Addendum 05

PROJECT: Fort Loramie Local Schools Athletic Complex Building & Associated Improvements
600 East Park Street
Fort Loramie, Ohio 45845

PROJECT #: 25041.00

This addendum form is a part of the Contract Documents and modifies the Bidding Documents dated December 11, 2025 with amendments and additions noted below.

SHEET NUMBER:
C1.1

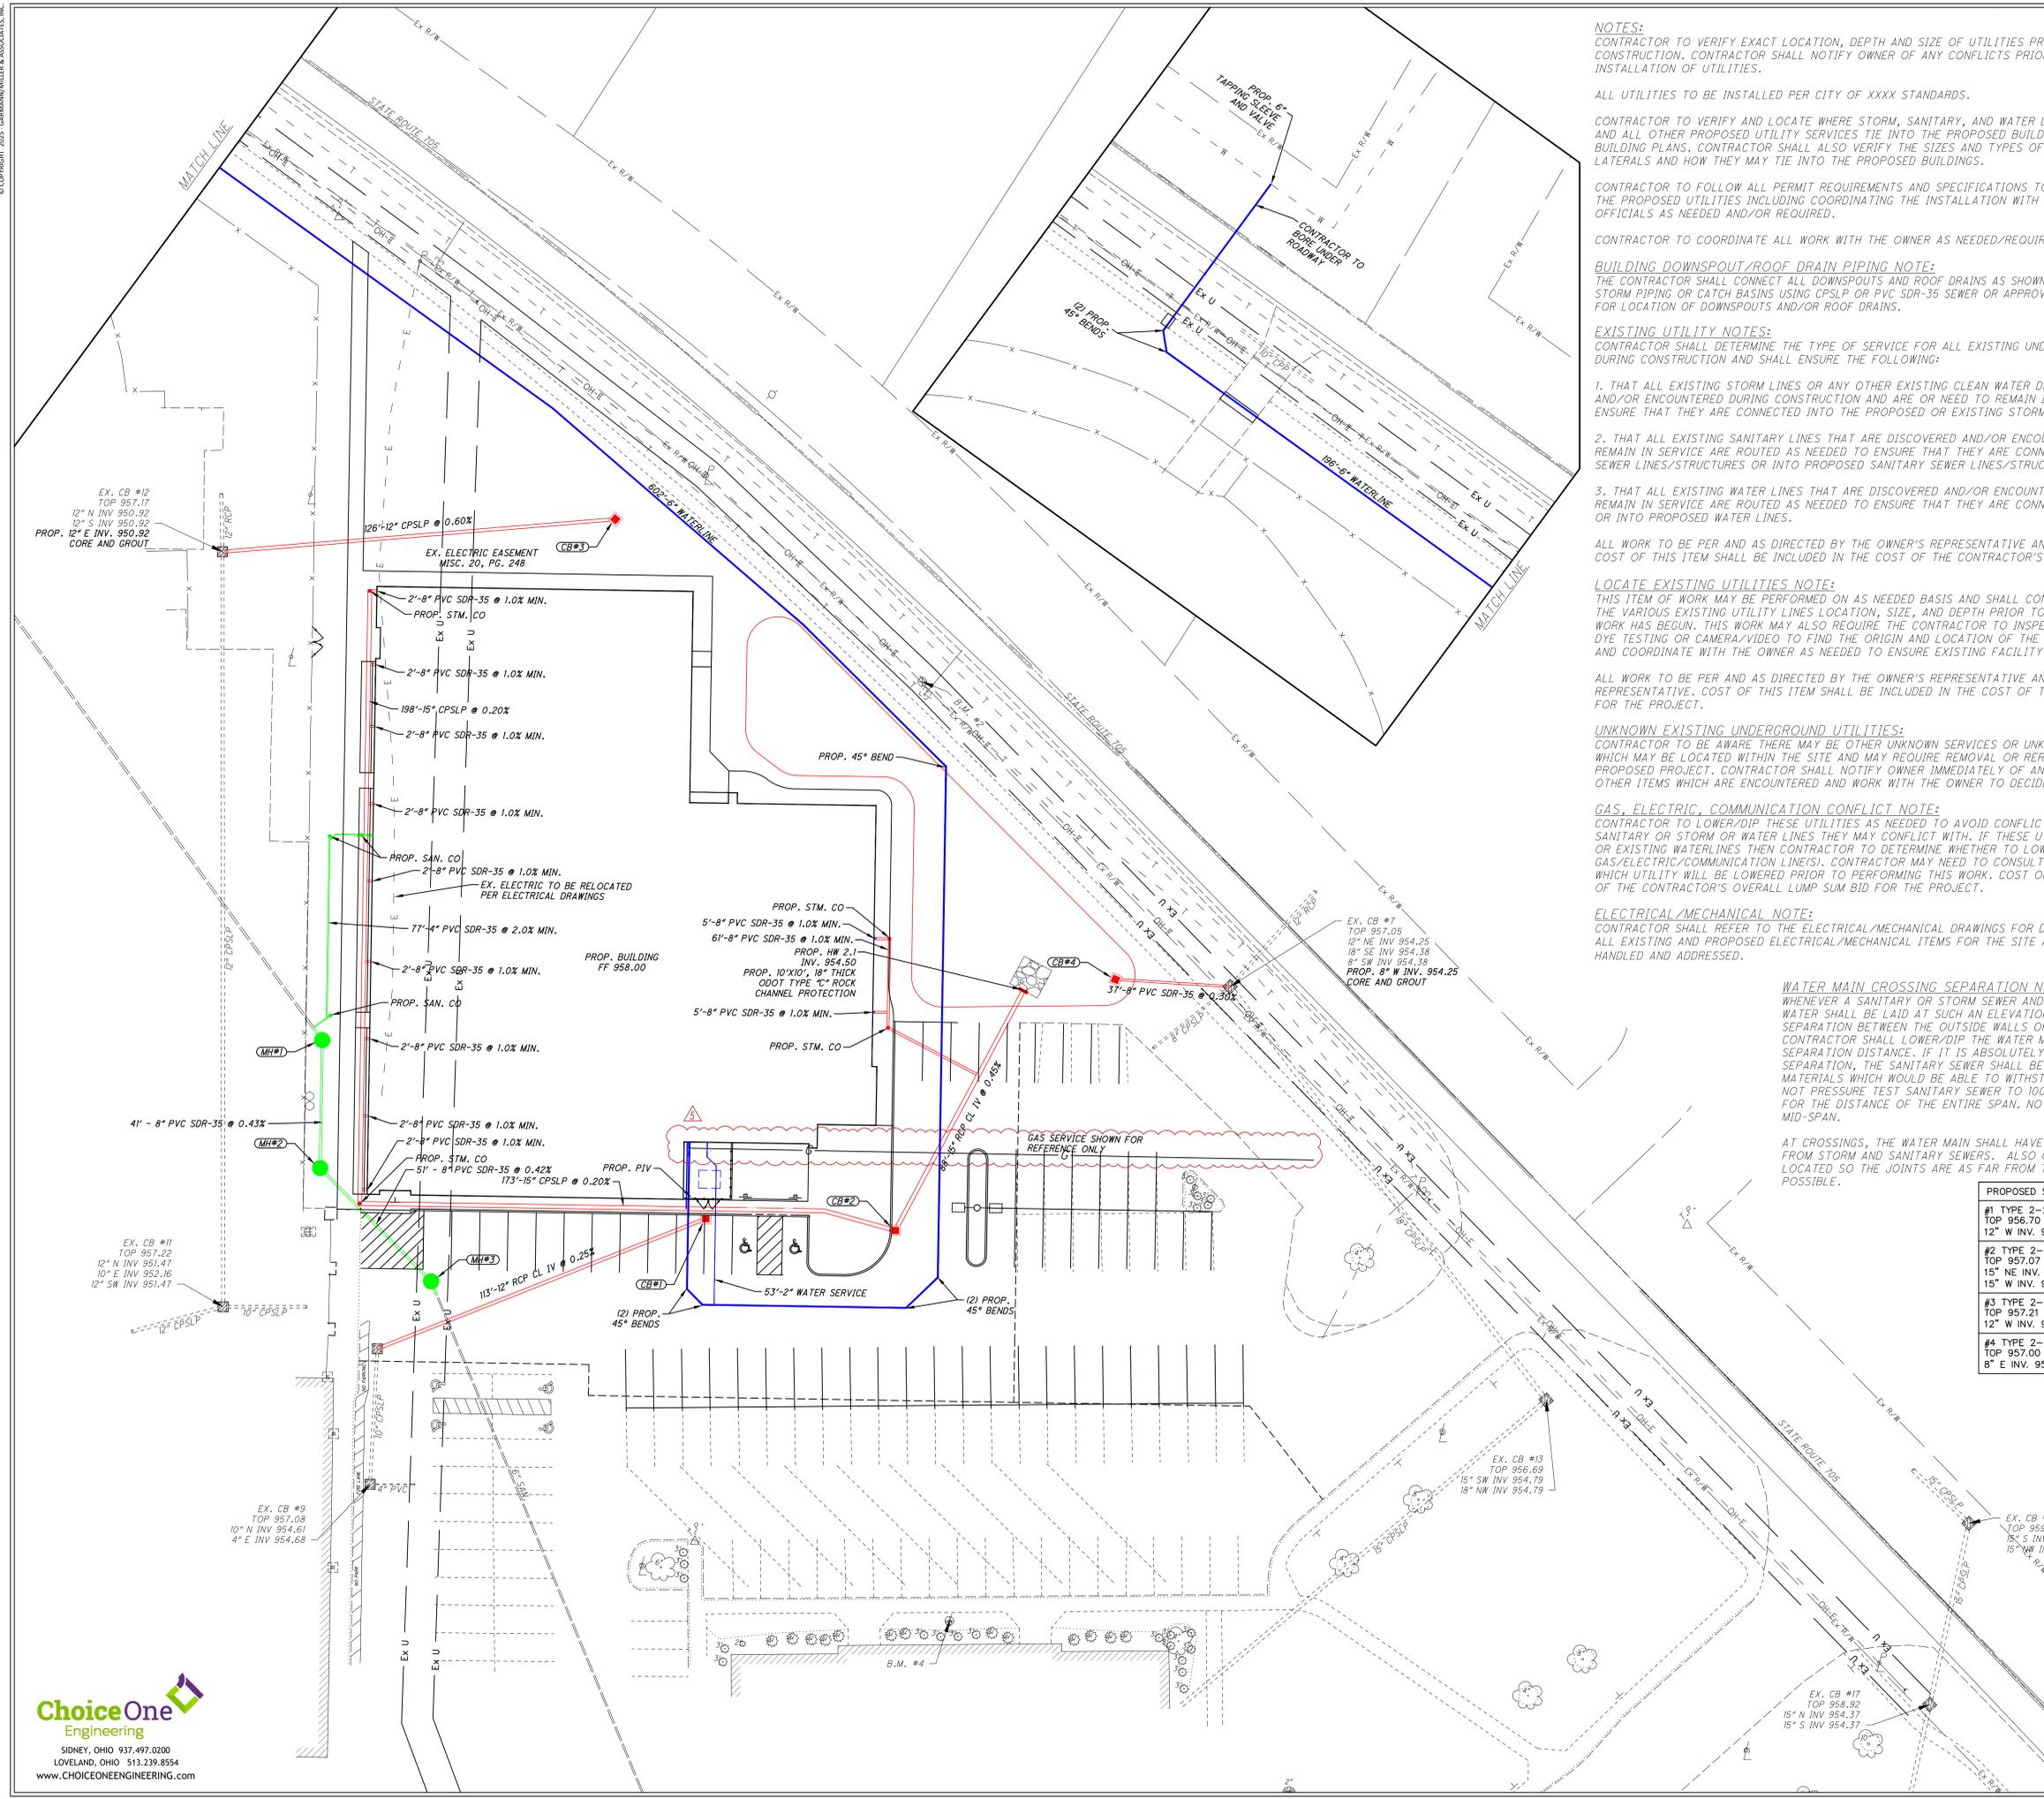
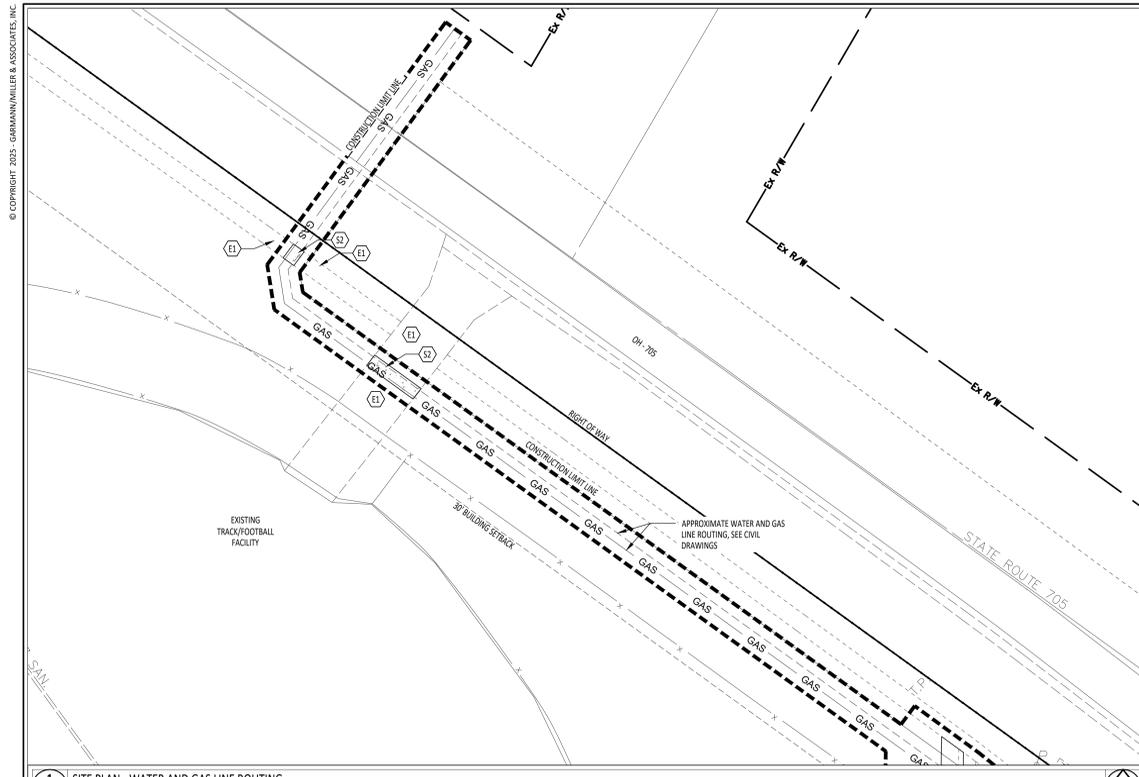
1. Sheet C1.1 – Utility Plan
 - a. Location for the gas service has been revised per engineer comments from Centerpoint Energy
2. Sheet L2.1 – Site Plan and Details

SHEET NUMBER:
L2.1

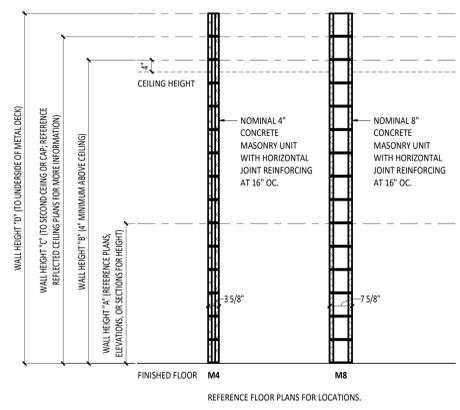
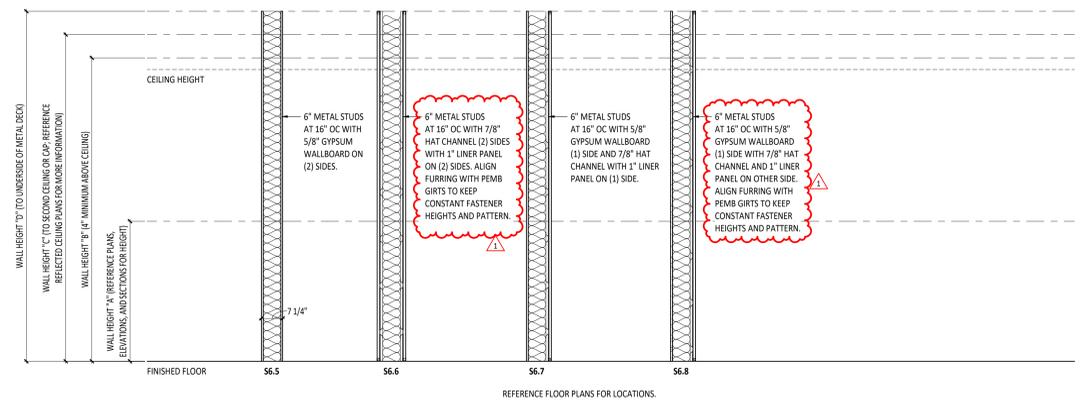
- a. Alternate 07 site furnishing details have been added. Locations to be determined by owner.
3. Sheet A0.2 – Wall Types/Mounting Height
 - a. Added furring to walls with liner panel and metal stud.

12. Alternate #07 is to provide Site Furnishings. There is not site furnishings spec or location designations on the drawings. Please advise.
 - a. **Response: L2.1 updated in Addendum 05**

SHEET NUMBER: A4.3

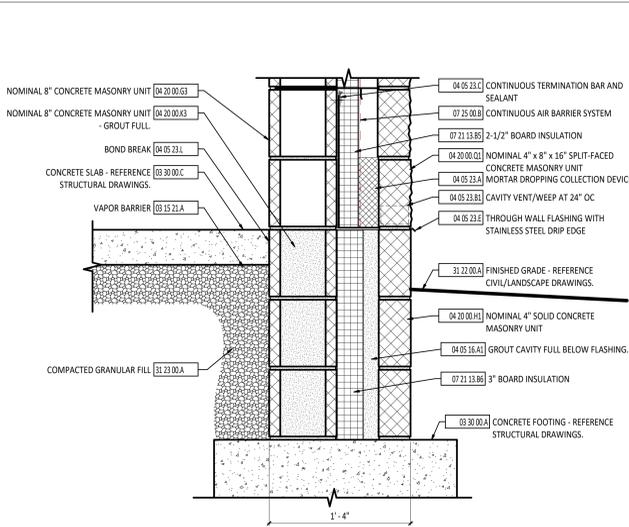
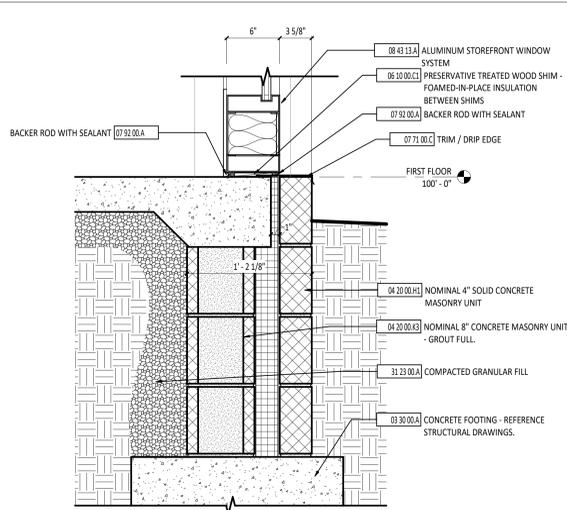
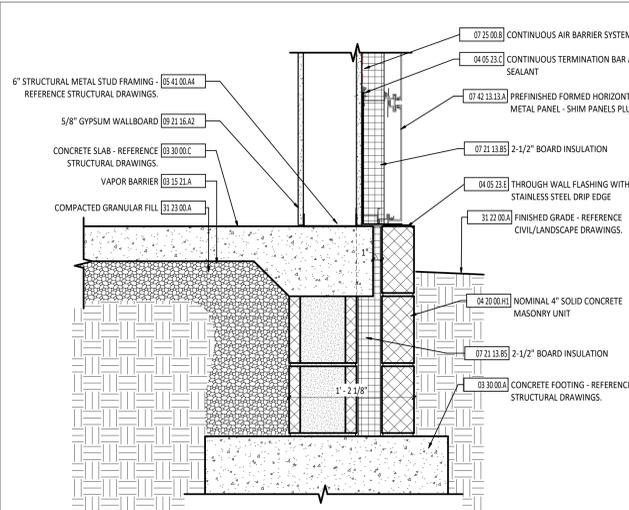
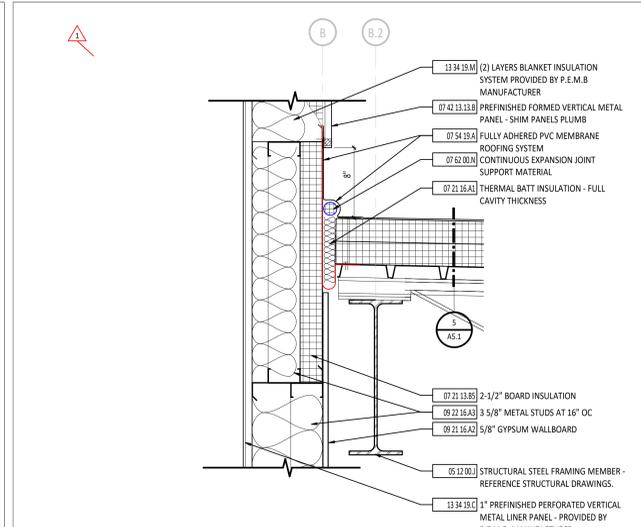
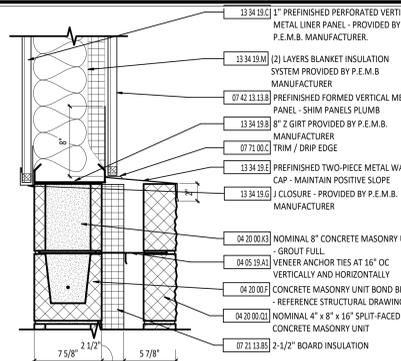
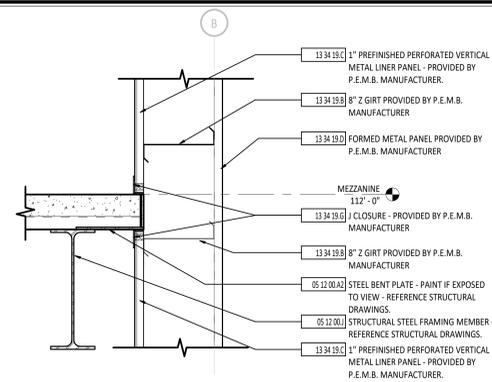
4. Sheet A4.3 – Section Details
 - a. Added furring to walls with liner panel and metal stud.
5. Sheet A6.1 – Door Schedule and Details
 - a. Added furring to walls with liner panel and metal stud.

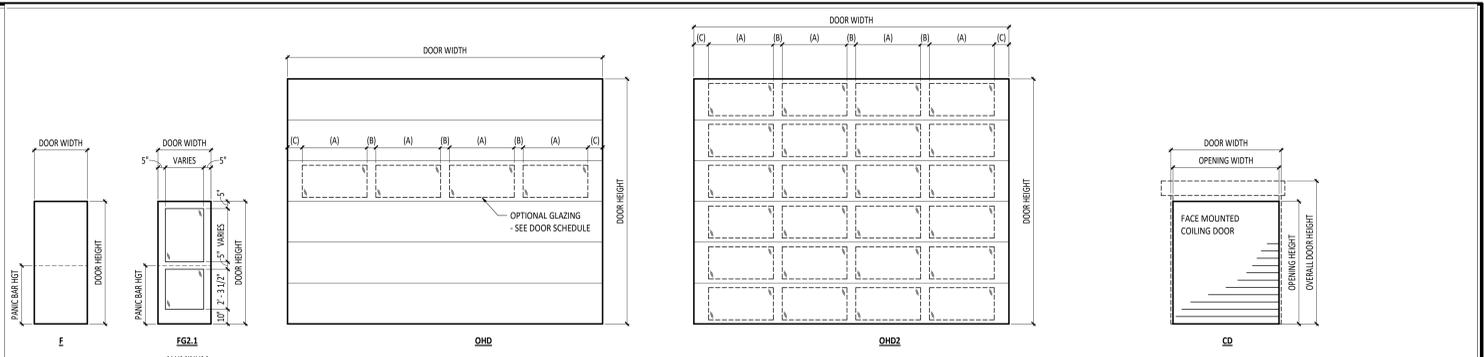
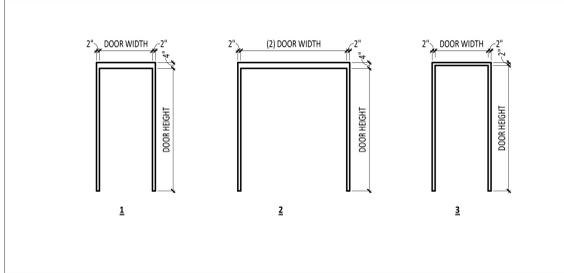
- b. Revised Door Schedule A121 to reflect wheel chair lift modifications in Addendum 04. A121 is now a single door.
6. Sheet A6.2 – Storefront & Door Elevations/Details

SHEET NUMBER:
A6.2

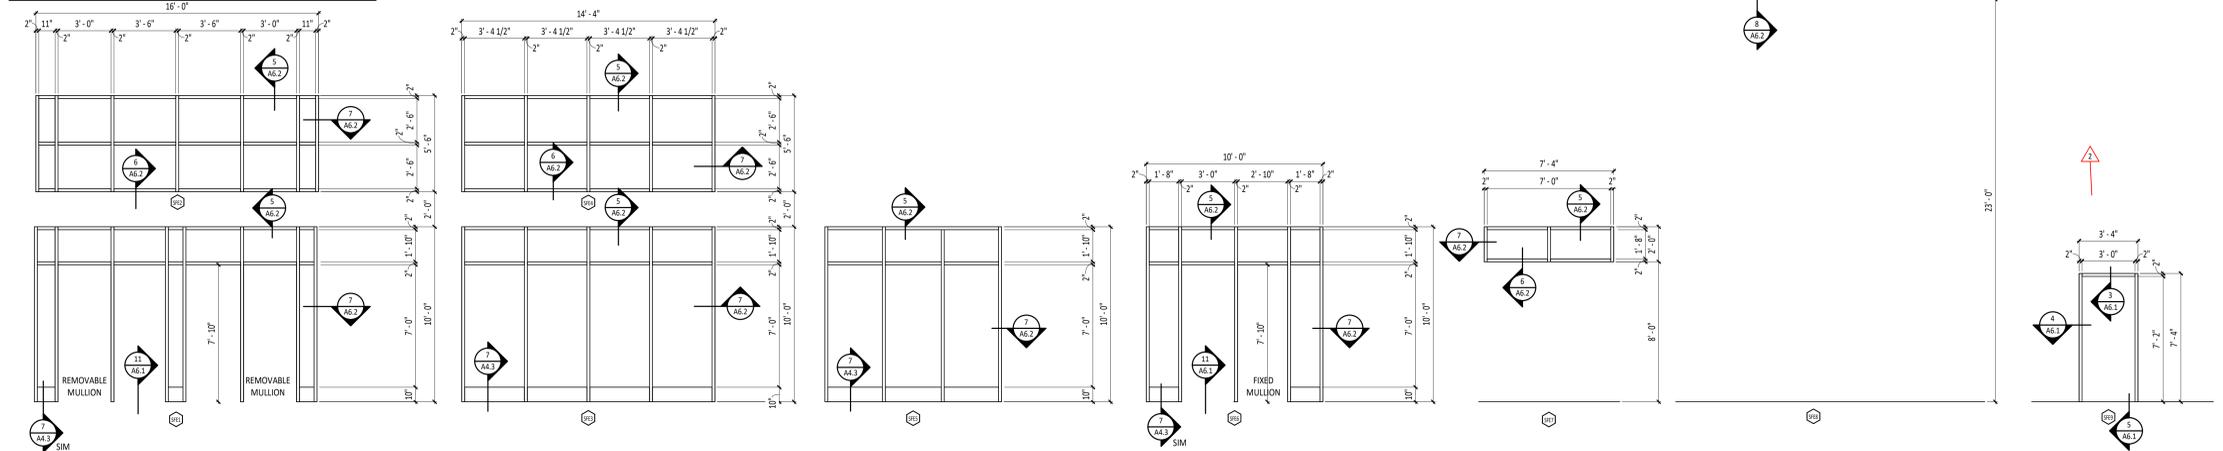
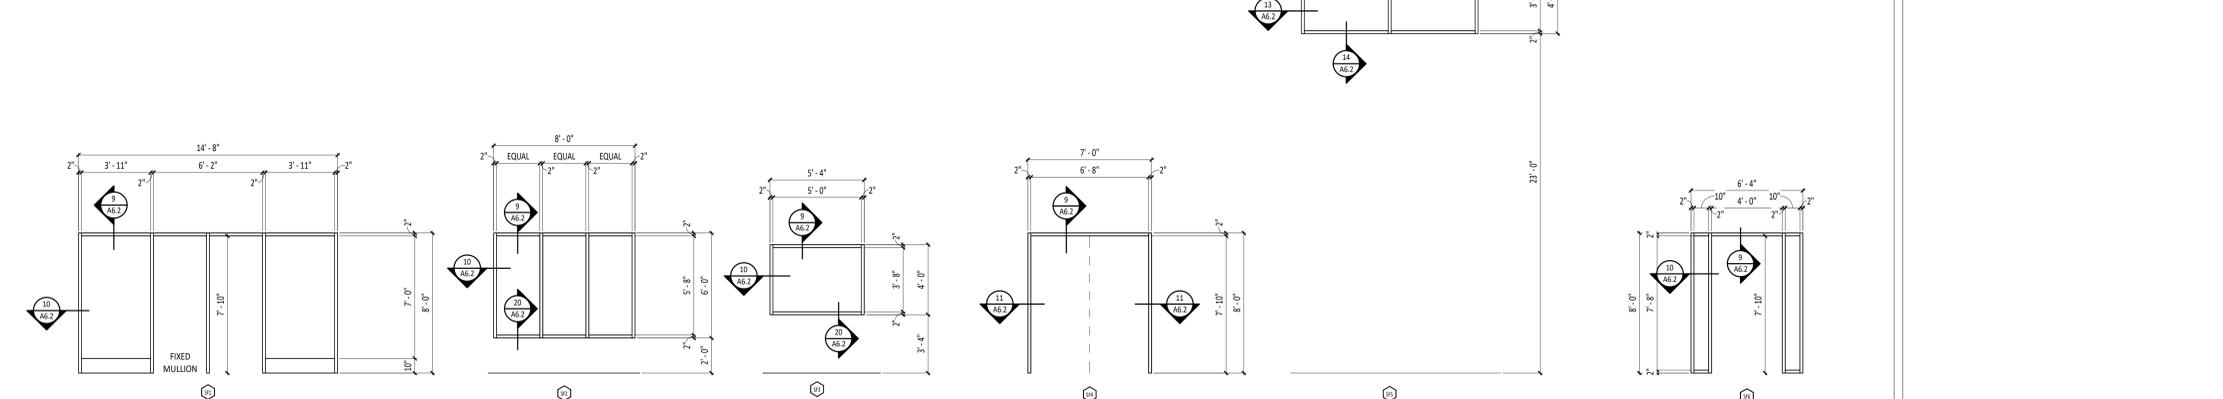
- a. Added furring to walls with liner panel and metal stud.
7. Sheet A8.1 – First Floor Equipment Plan
 - a. Remove metal shelving schedule
 - b. Revised Equipment schedule to show E01 and E04 to be provided by contractor.
